Proposal Request

Project:	Twin Falls Fire Station 2	PR No.:	PR-02
Project No.:	20-041	Date Issued:	May 27, 2022
Owner:	City of Twin Falls 214 Cheney Drive Twin Falls, ID 83301	Issued To:	Starr Corporation 2995 E 3600 N Twin Falls, ID 83301
Contract Date:	April 12, 2022	Attn:	Jason Derricott

ITEM 1: PR-02 Dedication Plaque Design and Room Signage Schedule

- 1.02 COORDINATE WITH ROOF PLAN.
- 1.04 COORDINATE WITH REFLECTED CEILING PLAN.
- 4.03 CMU BLOCK LAYOUT. RE. DETAIL B3 AND D3/A4.92.
- 11.34 O.F. C.I. ALERTING CALL MONITOR
- 23.05 DIESEL EXHAUST SYSTEM PENETRATION. COORDINATE WITH MECHANICAL AND STRUCTURAL DRAWINGS.

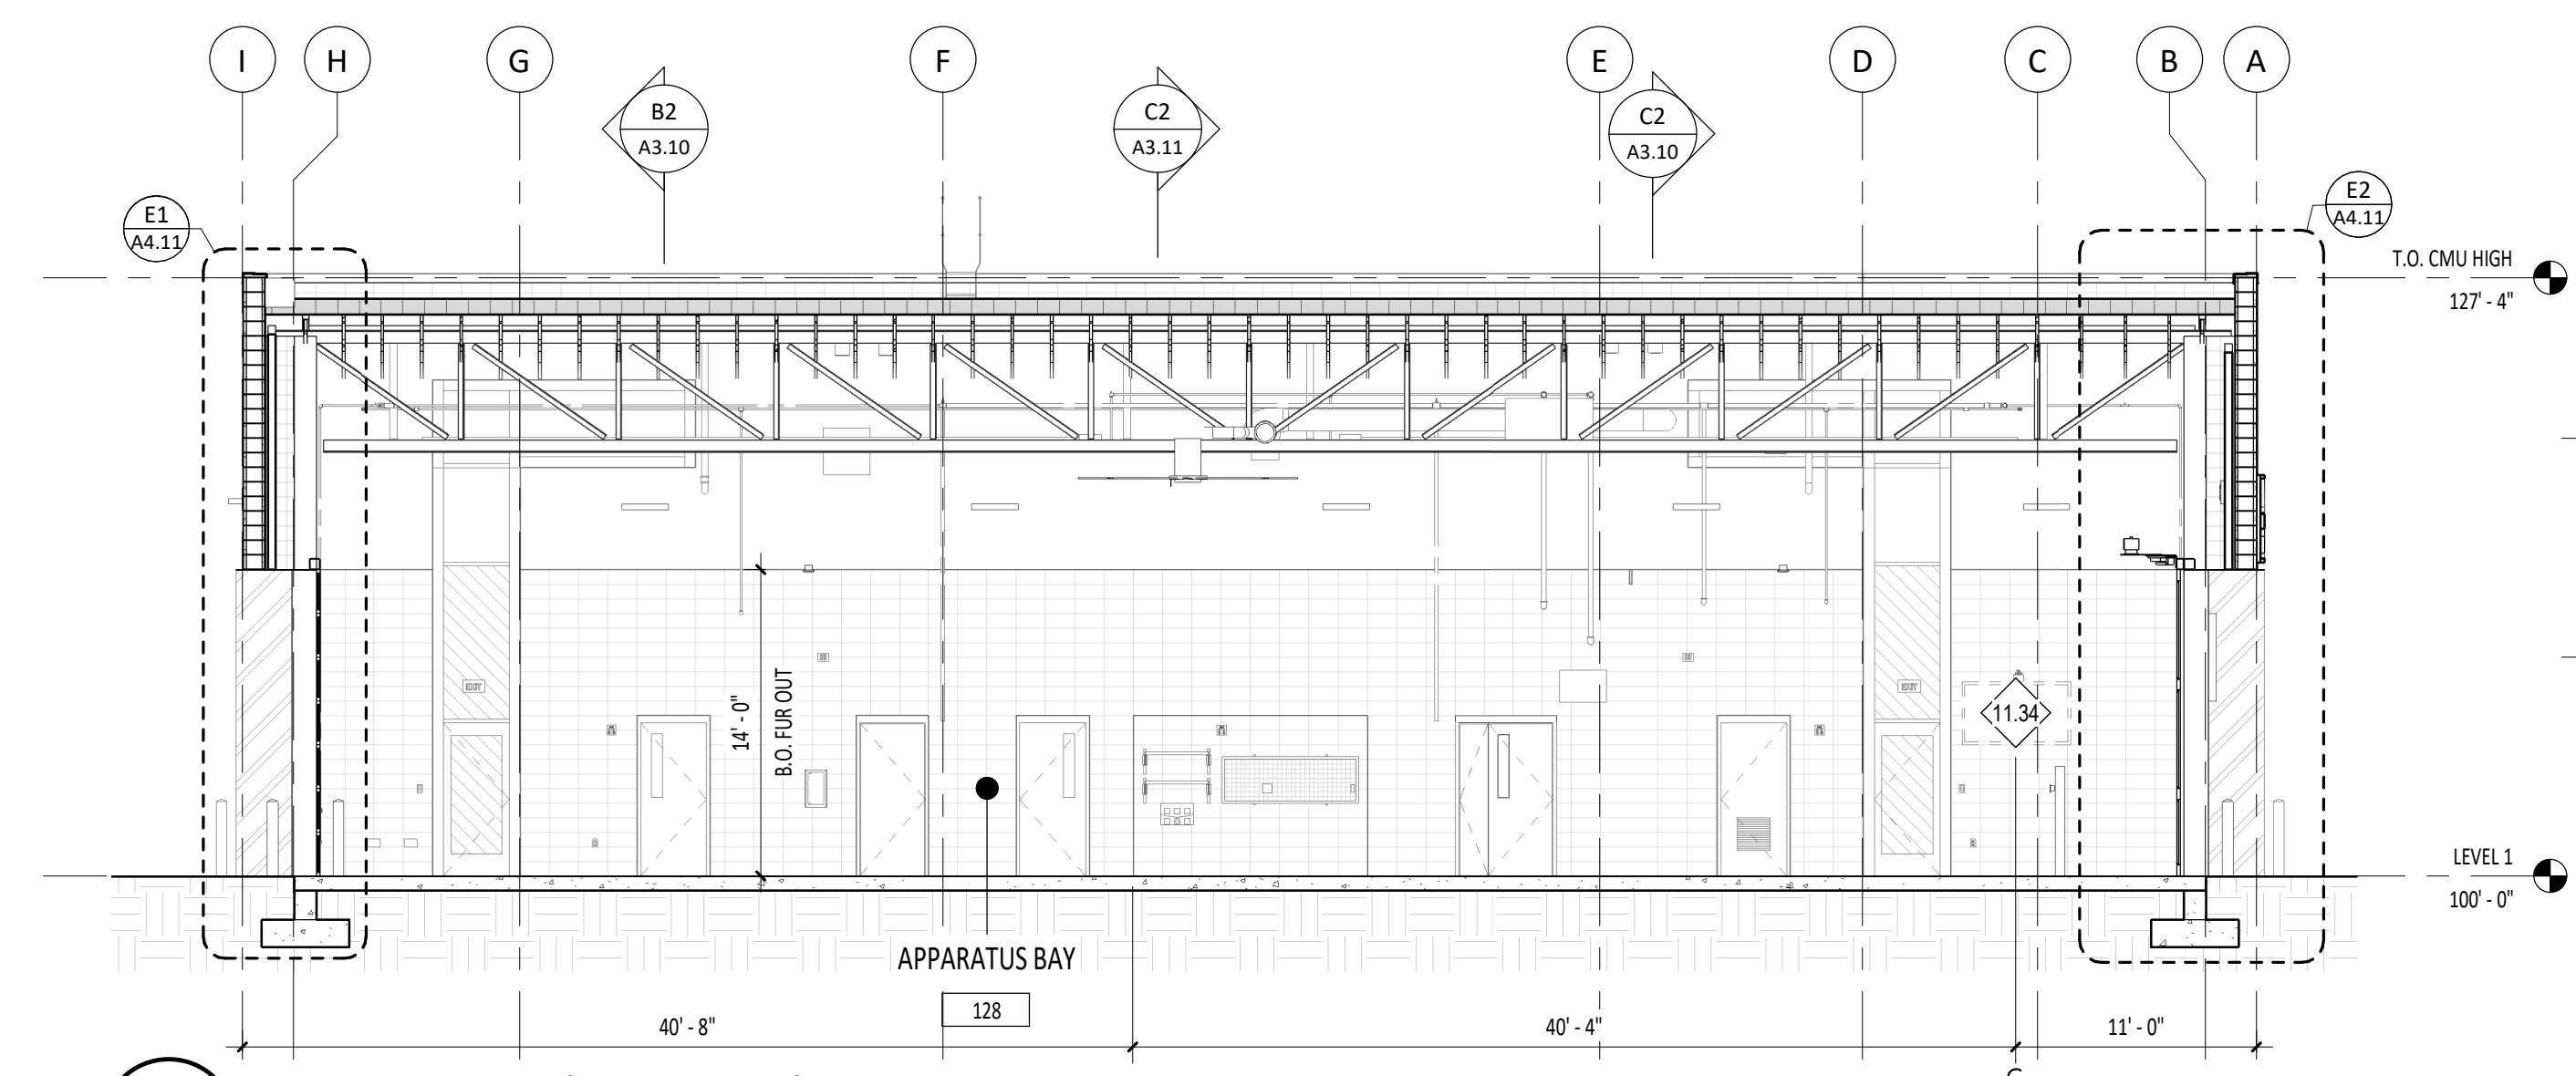
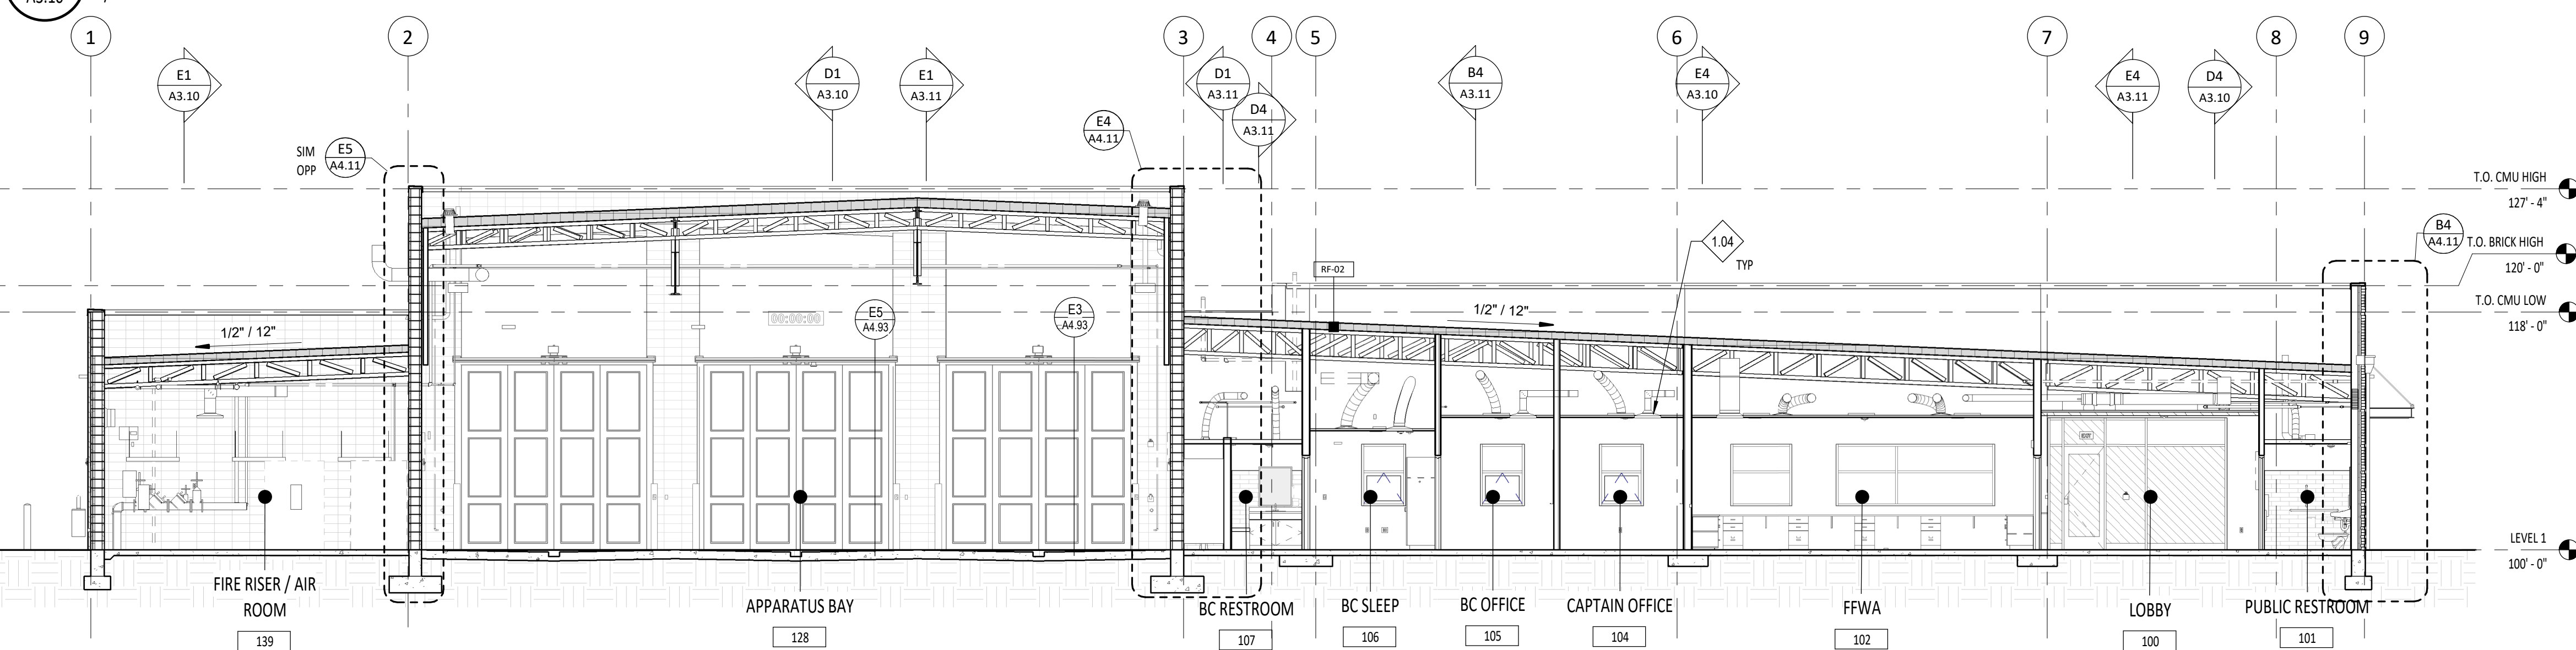
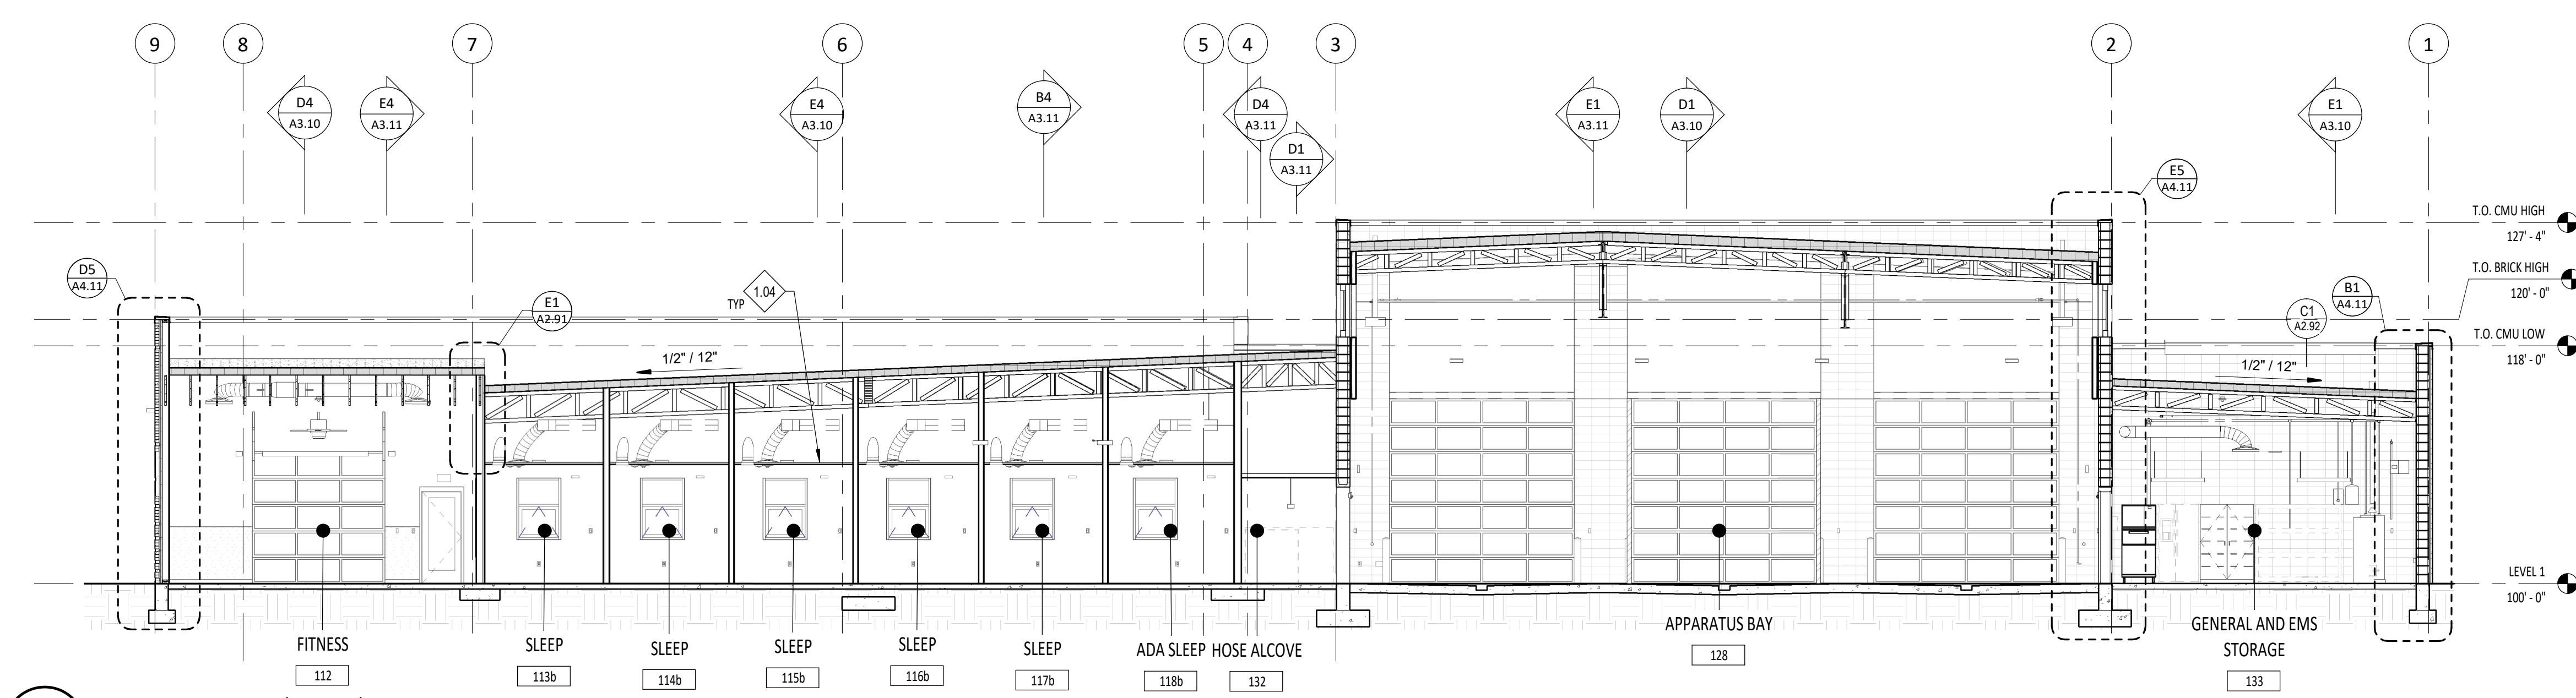
- E1/A3.10 – indicated typical location detail (B3/A4.01) for non bearing sloped CMU walls that go to deck

D2 PERPENDICULAR CMU WALL @ TRUSS
A4.01 1 1/2" = 1'-0"

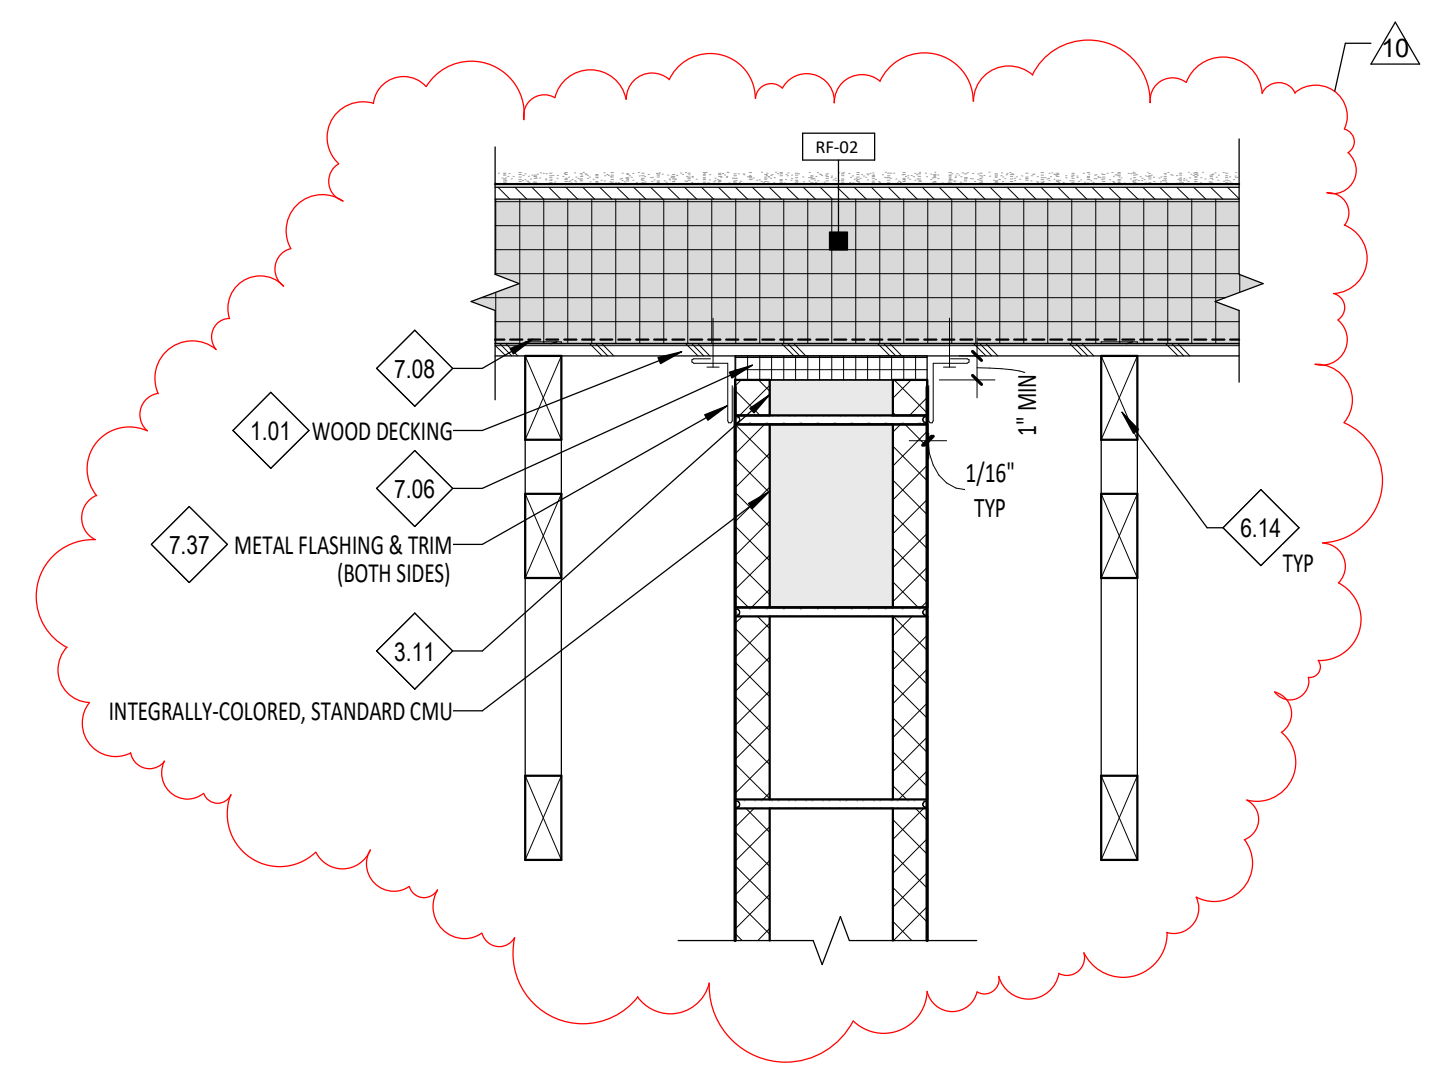
- D2/A4.01 – added detail PERPENDICULAR CMU WALL @ TRUSS for condition where CMU wall meets wood truss at wall at a perpendicular condition.
- D3/A4.01 – added INTERIOR WALL SECTION (GRID F / 2) between Electrical 135 and Apparatus Bay Restroom 134.
- B3/A4.01 – added detail TYP NON BEARING – SLOPED CMU WALL CONNECTION @ ROOF DECK for condition where parallel CMU walls with the wood trusses meet the roof decking.
- Ref Note: 1.01 COORDINATE WITH STRUCTURAL DRAWINGS
- Ref Note: 3.11 TOP OF CMU TO FOLLOW ROOF SLOPE. RE: BUILDING SECTIONS.
- Ref Note: 6.14 WOOD TRUSS. COORDINATE WITH STRUCTURAL DRAWINGS.
- Ref Note: 7.37 24 GAUGE SLIP TRACK FLASHING TO OVERLAP OVER CMU WALL.
